## CHANGE ORDER NO. 10

### Project: River Ranch County Park Phase 1 Improvements

## CHANGE EVENT #148 - DCO - Exhaust Air Louver

FLOOR PLANS -  
MAINTENANCE -  
MECH PLBG

MP250

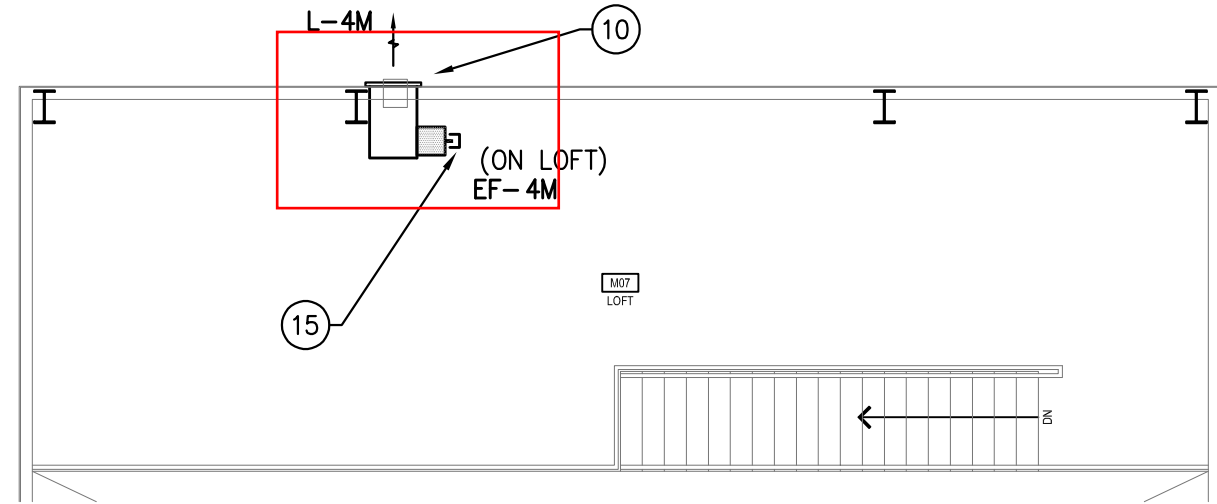
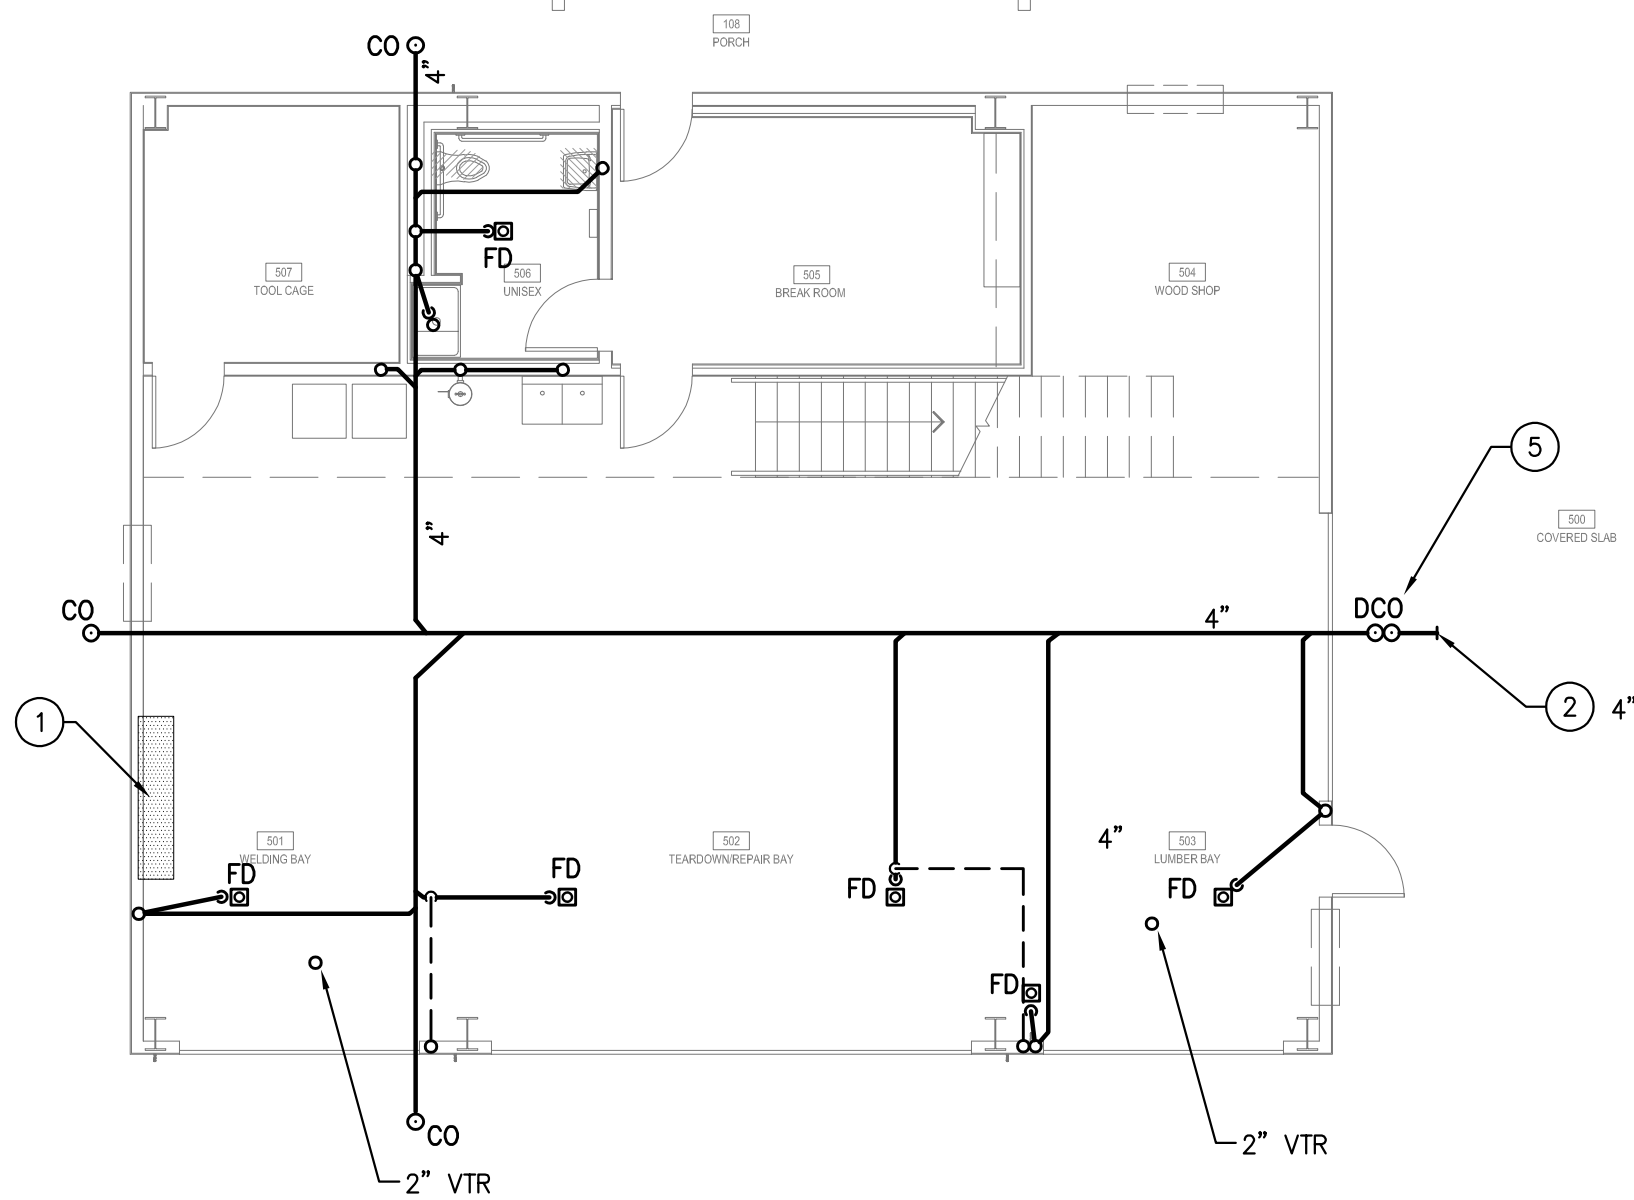
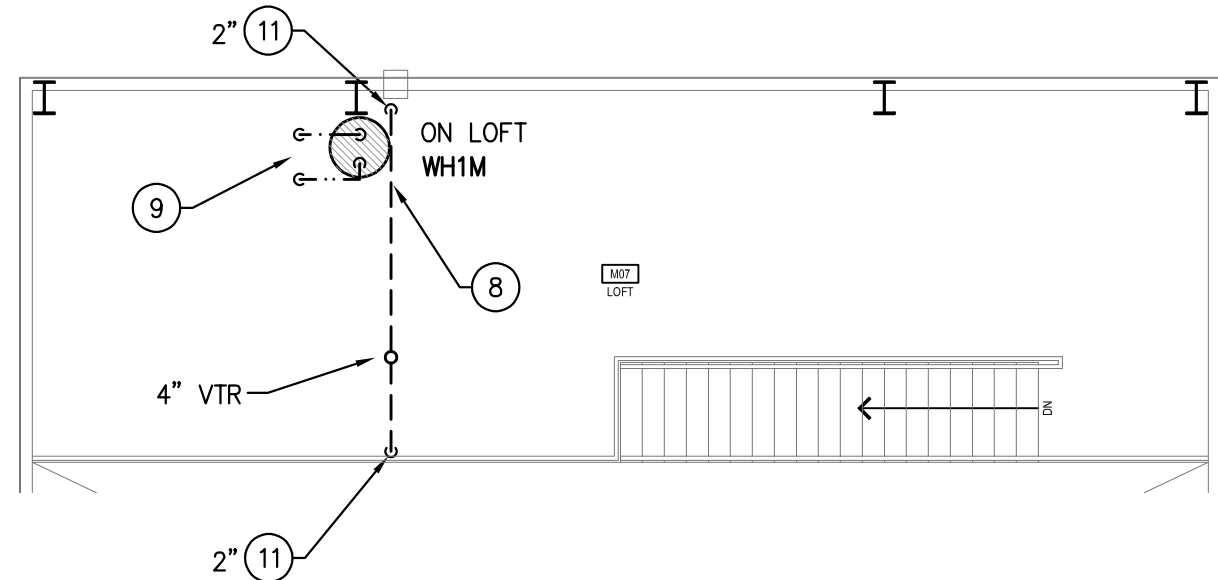
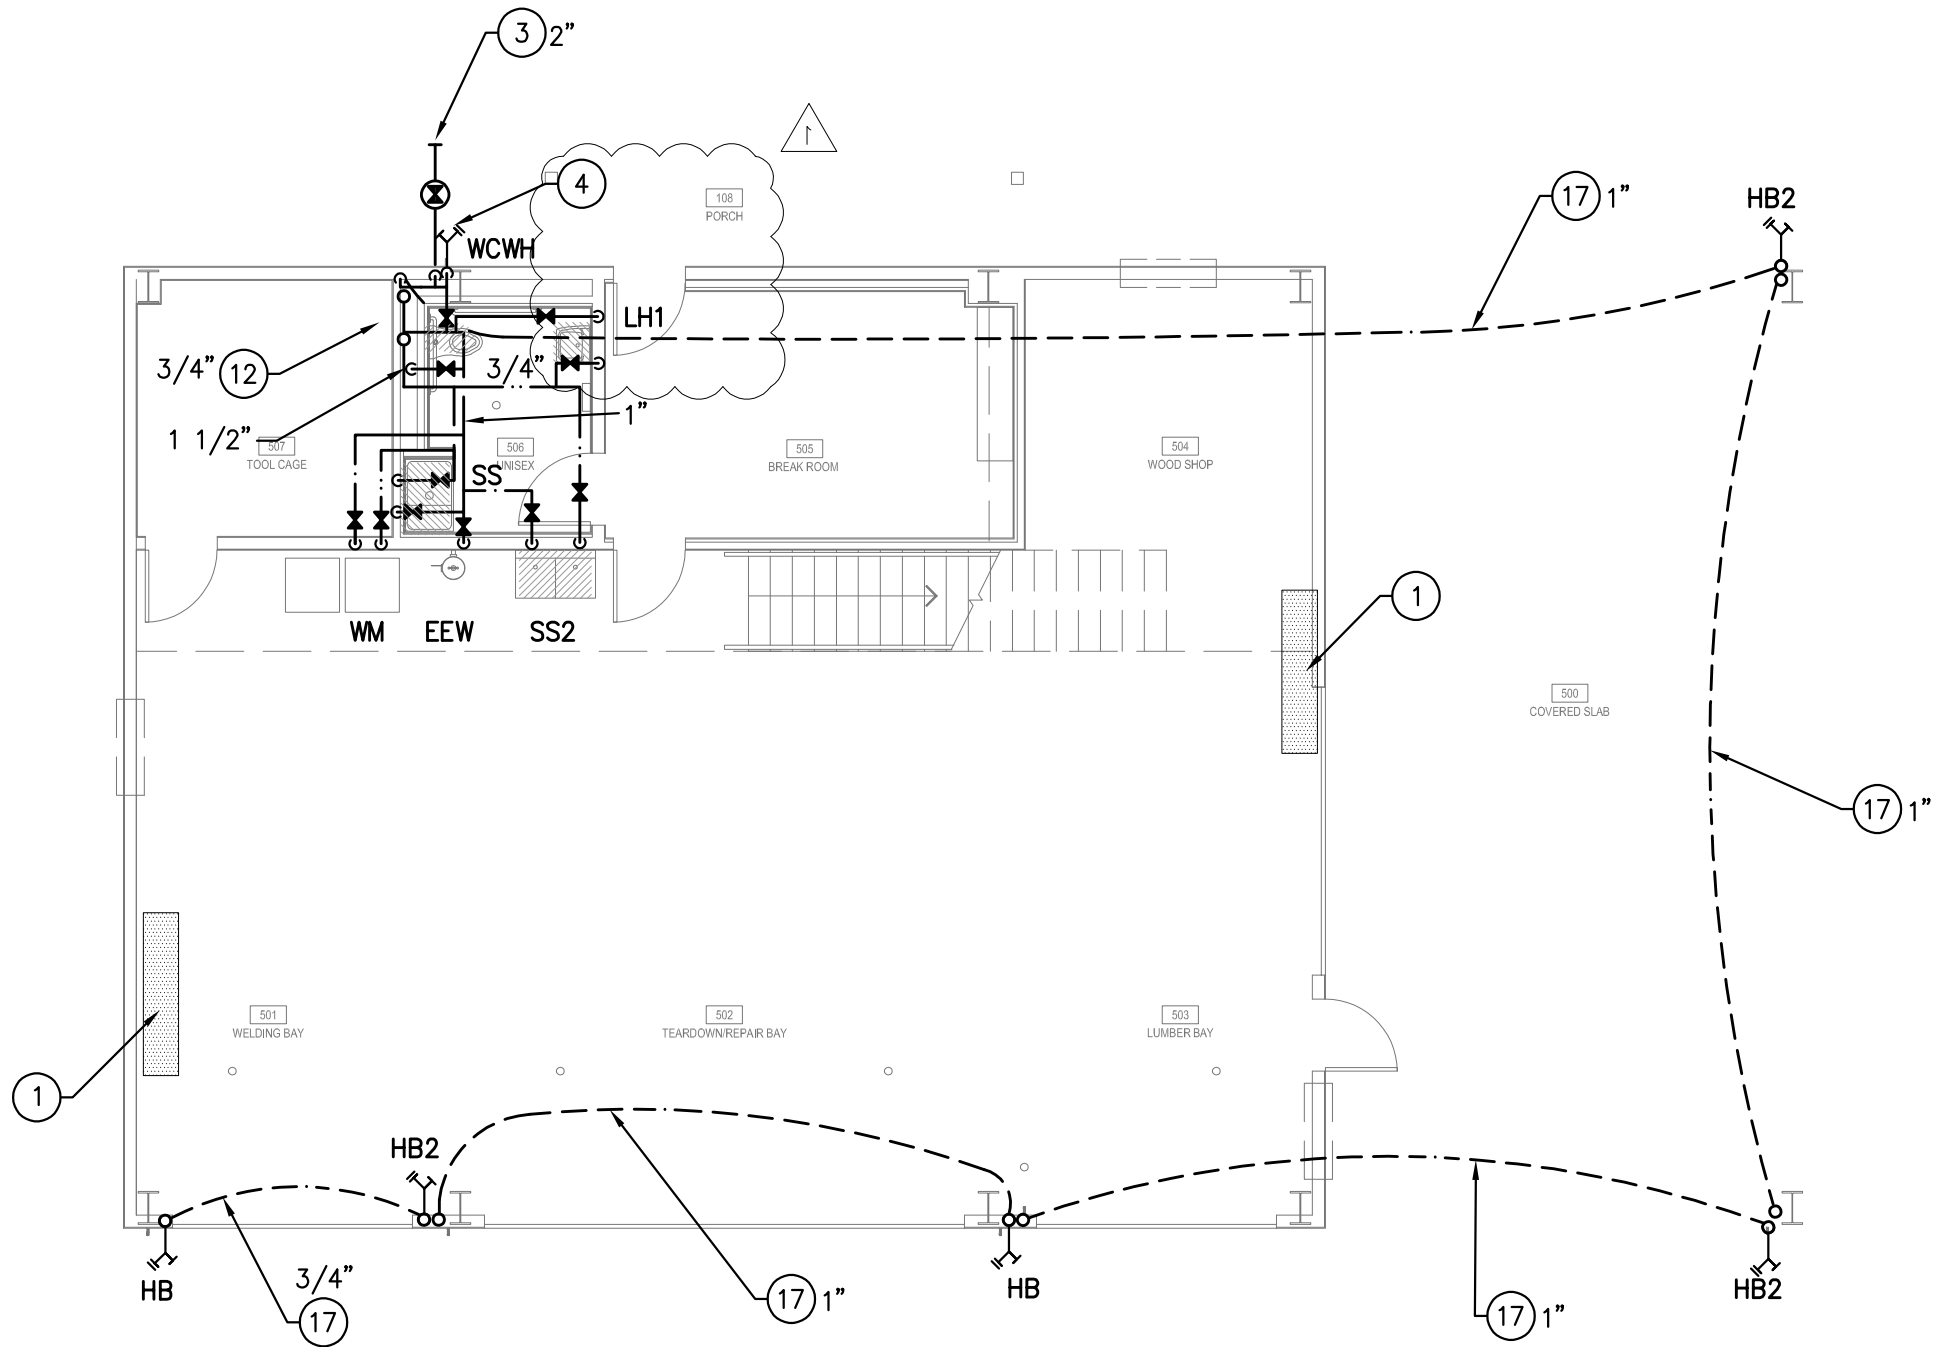
Deduct for 1 missing exhaust air louver in the restroom.

**Description:** Deduct for 1 missing exhaust air louver in the restroom.
